Cool Boss Technical Service Bulletin Installation and Operation Manual Update

BendPak TSB 120-052023

The purpose of this Technical Service Bulletin is to describe updates to the following two documents.

5900274, Rev. A3, page 6 & page 8.

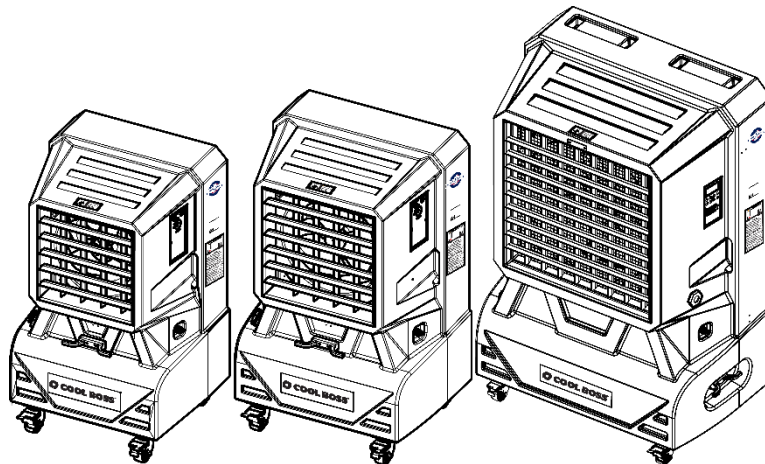
– **Replace** the following Max. Airflow (CFM) and Cooling Area (sq. ft.) data.

COOLBREEZE Swing Louver Models (Cool Boss Spec. Change)						
Model No.	CB-12 (existing specs)	CB-12 Revised Spec	CB-14 (existing specs)	CB-14 Revised Spec	CB-26 (existing specs)	CB-26 Revised Spec
Max. Airflow (CFM)	1,565	1,850	2,300	2,715	6,027	7,115
Cooling Area (sq. ft.)	650	770	850	1,005	2,585	3,055
